Contract #: 04-0120F4Cty: SF/ALA Rte: 80 PM: 13.2/13.9File #: 69.25B**QUALITY ASSURANCE -- NON-CONFORMANCE REPORT****Location:** Changxing Island, Shanghai, P.R. China**Report No:** NCR-000675**Prime Contractor:** American Bridge/Fluor Enterprises, a JV**Date:** 04-Feb-2010**Submitting Contractor:** Zhenhua Port Machinery Company, Ltd (ZPMC), Changxing Island**NCR #:** ZPMC-0643**Type of problem:**

Reference Description: Improper Storage and Handling of Lift 12 West Floorbeam 3069-004**Description of Non-Conformance:**

To:	AMERICAN BRIDGE/FLUOR, A JV 375 BURMA ROAD OAKLAND CA 95607	Date:	06-Feb-2010
Dear:	Mr. Charles Kanapicki	Contract No:	04-0120F4 04-SF-80-13.2 / 13.9
Attention:	Mr. Thomas Nilsson Project/Fabrication Manager	Job Name:	SAS Superstructure
Subject:	NCR No. ZPMC-0643	Document No:	05.03.06-000633
Reference Description:	Improper Storage and Handling of Lift 12 West Floorbeam 3069-004

HSR1(B)-8152

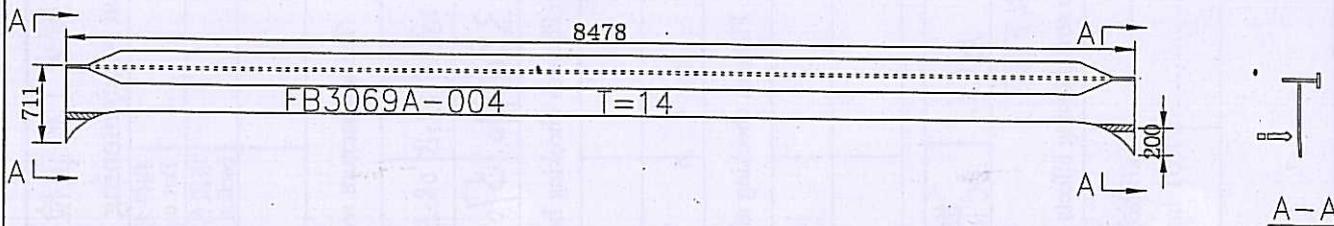
The provided HSR does not adequately address the repairs required to resolve the NCR. The HSR indicates that the damage was a result of "bounce distortion" yet the corrective action says to control welding parameters. Additionally, the amount of distortion noted in the NCR could not have been corrected by heat alone. Please provide a description of the methods actually used to repair the bent flange.

缺陷去除方法(Defect Removal Method): Flame Straightening by oxygen acetylene 运用氧乙炔进行校火

后续NDE(Post-Removal NDE): After finishing heat straightening, the weld of the heat area shall perform NDT according to the approved shop drawing 校火后, 根据图纸要求对热影响区域进行NDT检测。

纠正措施(Corrective Action(s)): Control current, voltage and weld speed according to relevant WPS. If necessary anti-deformation or hold down device can be added. 依据相应的WPS的要求控制电流, 电压和焊接速度。如有必要, 可使用反变形设施进行校正。

HSR1(B)-8152

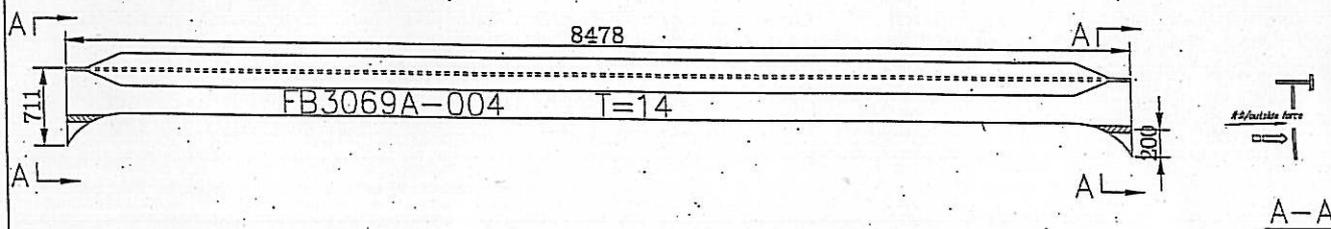
If heat straightening was performed, an HSR, not an HSR1, would be required to be submitted as the amount of distortion to be corrected requires Engineer's approval. Additionally, the application of force as shown in the provided HSR1, is not acceptable.

The proposed resolution is unacceptable. Taking action on a "case by case basis" in the future does not really address the quality management issue. It is unacceptable to utilize outside force as required to perform the type of heat straightening done in this case. The piece that was bent should have been removed, or the contractor should have pointed out that the majority of the base material is removed during welding and backgouging removes most of the base material.

缺陷去除方法(Defect Removal Method): Oxy-acetylene hand torch 氧乙炔火焰校正

Provide VT to the heat straightened area and its close area. Perform MT if necessary. 对火工校正区域及其临近区域进行VT检测。如有必要,进行MT检测。

Fasten subcomponent to transportation trailer securely prior to transport. 转运之前将构件安全地紧固在转运拖车上。
